**Engineering Evaluation for Soil and Dry Sediment at
RVAAP-01 Ramsdell Quarry Landfill
Version 1.0**

**Ravenna Army Ammunition Plant
Ravenna, Ohio**

**DRAFT ENGINEERING EVALUATION FOR SOIL AND DRY SEDIMENT AT RVAAP-01 RAMSDELL QUARY LANDFILL
RAVENNA ARMY AMMUNITION PLANT, RAVENNA OHIO
COMMENT RESPONSE TABLE
REVISION 3**

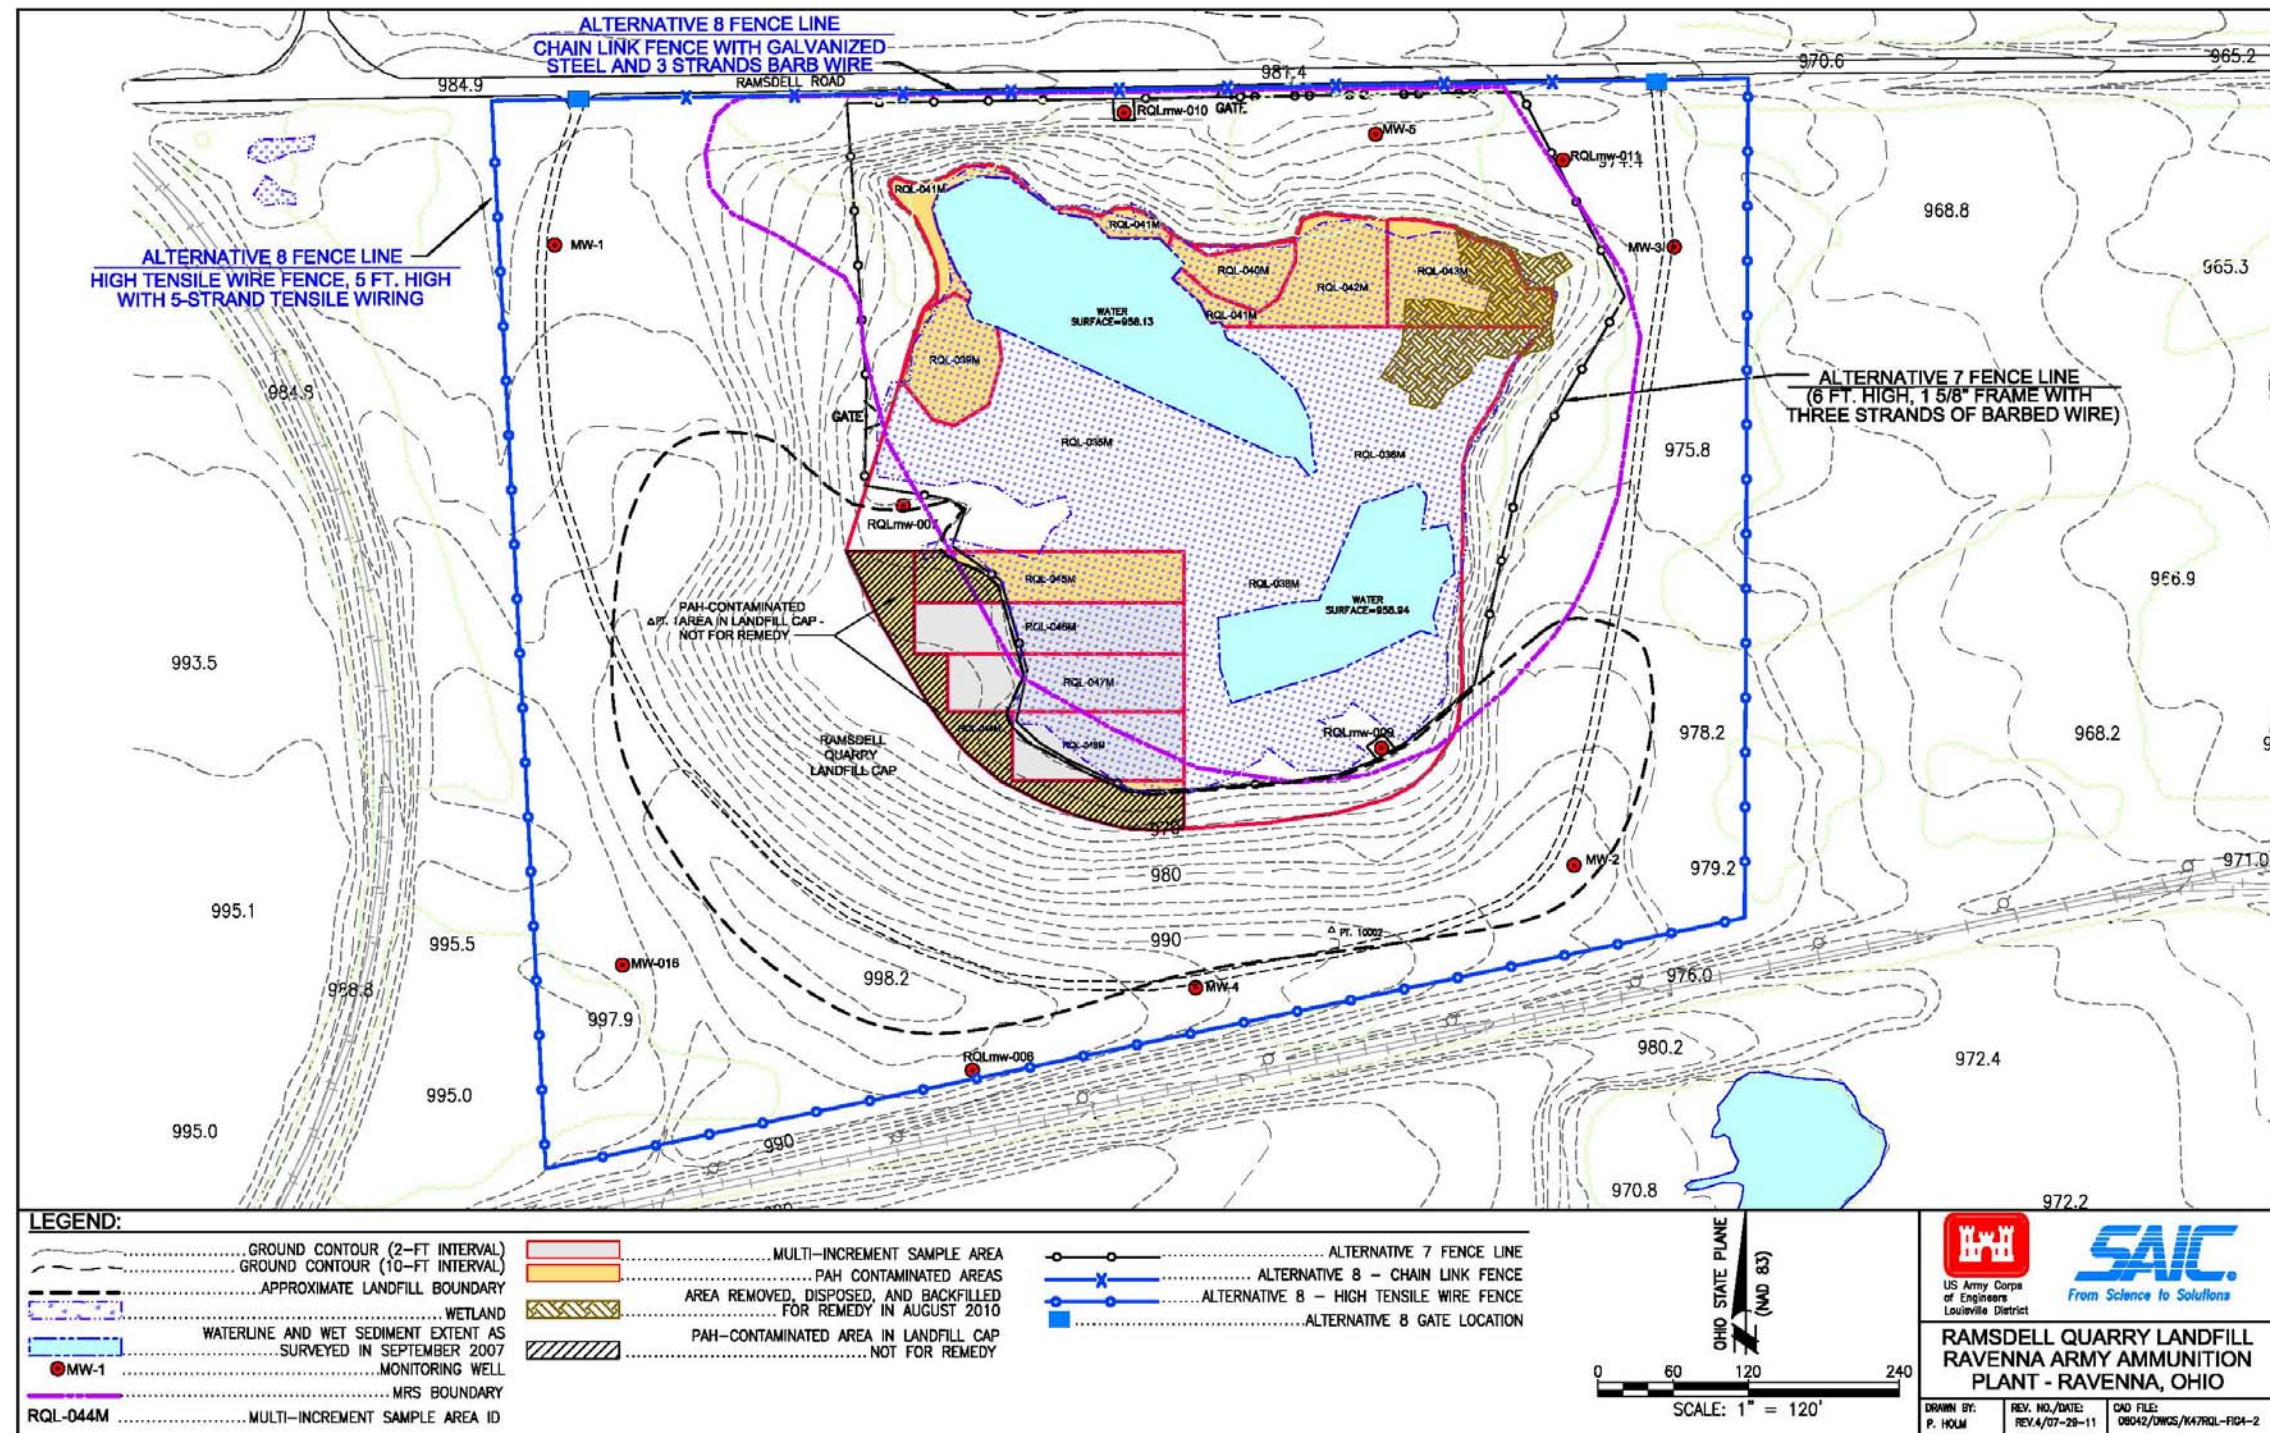
Per the request of Ohio EPA, the legend in Figure 4-1 changes the term “Construction Fence” to “Alternative 7 Fence Line”. Additionally, the fence line for the new Alternative 8 is incorporated into Figure 4-1.

Figure 4-1 presents a preliminary layout of fencing to be installed under Alternative 8.

Installation of this fence encompasses the two areas specified in the RQL ROD (i.e., RQL-039M and RQL-040M), the areas identified to exceed COC CUGs (RQL-041M, RQL-042M, RQL-043M, and RQL-045M), and the closed, sanitary landfill. The fence line will provide the U.S. Army and NBG access control to the closed, sanitary landfill. Gates will be in the fence line so activities such as maintenance of the quarry bottom, landfill cap inspections, and mowing may take place. Placement of the gates will be finalized in a Remedial Design. Additionally, signage notifying personnel of the presence of asbestos in the quarry will be placed on the fence.
